Access Compliance Report
Public Rights-of-Way
(Curb Ramps)

Intersection ID: 23868	**Main Street: PINEVILLE-MATTHEWS_RD**	**Cross Street: REVERDY_LN**	**Location: E**
ADA ID: D2EB8D1B4EBB	**Ramp Type: PerpDiag**	**Initial Pass/Fail: Fail** **Overall Compliance: No**	**Severity Score: 8.75**

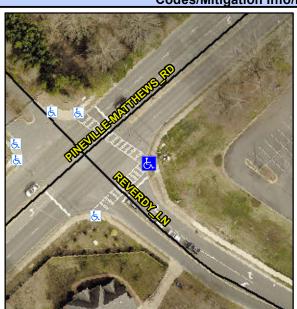
Not Found, R304.5.1

Compliance	Description	Data	Compliance	Description	Data
N/A	Ramp Length (in)	121.0	Yes	Ramp Slope (%)	7.0
No	Ramp Width (in)	40.0	Yes	Ramp XSlope (%)	0.1
N/A	Flare Type LT	N/A	N/A	Flare Type RT	N/A
N/A	Flare Slope LT (%)	N/A	N/A	Flare Slope RT (%)	N/A
N/A	Flare Traversable LT?	N/A	N/A	Flare Traversable RT?	N/A
N/A	Landing Length (in)	N/A	N/A	DWS Provided?	N/A
N/A	Landing Width (in)	N/A	N/A	DWS Contrast?	N/A
N/A	Landing Slope (%)	N/A	N/A	DWS Length (in)	N/A
N/A	Landing X Slope (%)	N/A	N/A	DWS Full Width?	N/A
N/A	Landing Curb? (Y/N)	N/A	N/A	DWS Offset (in)	N/A
N/A	Shared Landing?	N/A			
N/A	Gutter Ponding?	N/A	N/A	Gutter Slope (%)	N/A
N/A	Gutter Lip Ht (in)	N/A	N/A	Gutter X Slope (%)	N/A
N/A	Painted X Walk1?	Yes	N/A	Painted X Walk2?	Yes
	X Walk 1 Direction	To NW		X Walk 2 Direction	To SW
N/A	X Walk 1 Width (in)	112.0	N/A	X Walk 2 Width (in)	112.0
	X Walk 1 Slope (%)	1.9		X Walk 2 Slope (%)	2.1
	X Walk 1 X Slope (%)	1.5		X Walk 2 X Slope (%)	0.0

Remove & Replace Curb Ramp With Two New Directional Ramps or Equivalent.
